11/15/01

Errata: CS4391 Data Sheet revision DS335PP3 dated Apr '00

20L SOIC (300 MIL BODY) PACKAGE DRAWING

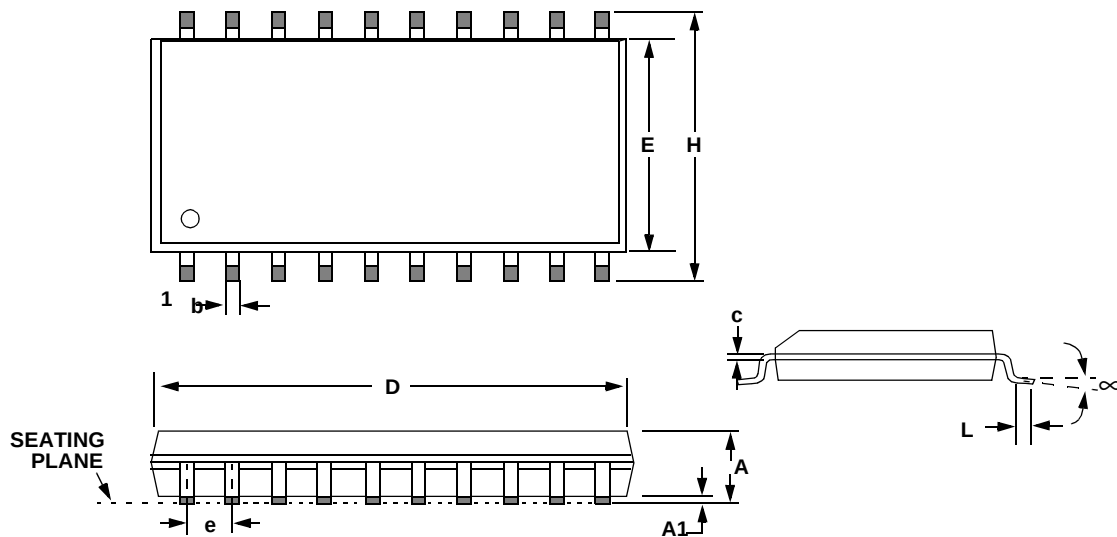
-The CS4391 is also offered in a 300 MIL SOIC package. It can be ordered with the CS4391-KS designation. The KS package specifications have been included in this errata.
